Access Compliance Report Public Rights-of-Way (Curb Ramps)

Main Street: FLINTRIDGE_AVE		Cross Street: TISBURY_WAY		Location:	S
ADA ID: RPRK211104134102	Ramp Type: Type 4 - Parallel	Initial Pass/Fail: Fail	Overall Compliance: No	Severity Score:	30

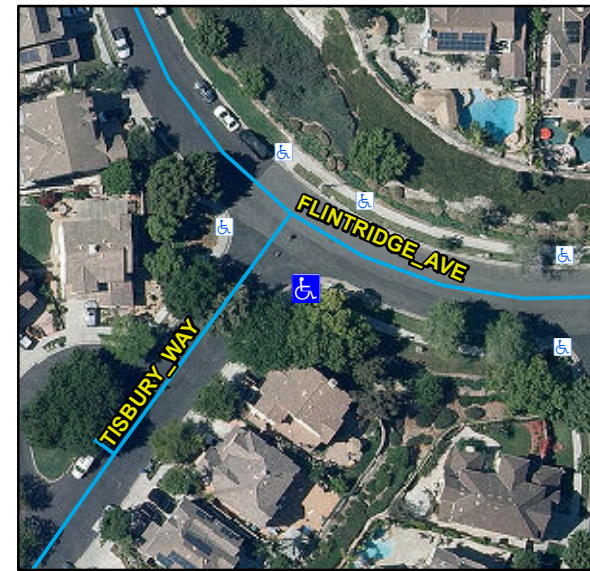
Compliance	Description	Data	Compliance	Description	Data
N/A	Ramp Length LT (in)	118	N/A	Ramp Length RT (in)	118
Yes	Ramp Width LT (in)	55	Yes	Ramp Width RT (in)	55
No	Ramp Run Slope LT (%)	15.1	Yes	Ramp Run Slope RT (%)	1.1
Yes	Ramp Cross Slope LT (%)	1.3	Yes	Ramp Cross Slope RT (%)	0.4
N/A	Landing Present	N/A	N/A	DWS Provided	N/A
N/A	Landing Length (in)	N/A	N/A	DWS Contrast	N/A
N/A	Landing Width (in)	N/A	N/A	DWS Length (in)	N/A
N/A	Landing Run Slope (%)	N/A	N/A	DWS Full Width	N/A
N/A	Landing Cross Slope (%)	N/A		DWS Offset Type	N/A
N/A	Landing Movement Obstructed?	N/A	N/A	DWS Offset Left (in)	N/A
	Landing Movement Type	N/A	N/A	DWS Offset Right (in)	N/A
N/A	Landing Shared	N/A			
N/A	Clear Space	Yes			
N/A	Clear Space To Crosswalk (in)	N/A			
N/A	Marked Crosswalk 1	No	N/A	Marked Crosswalk 2	No
	Crossing 1 Direction	NE		Crossing 2 Direction	NW
	Marked Crosswalk 1 Width (in)	N/A		Marked Crosswalk 2 Width (in)	N/A

Remove & Replace Curb Ramp With Two New Directional Ramps or Equivalent.

R204.3, R304.3.2, STD 1115
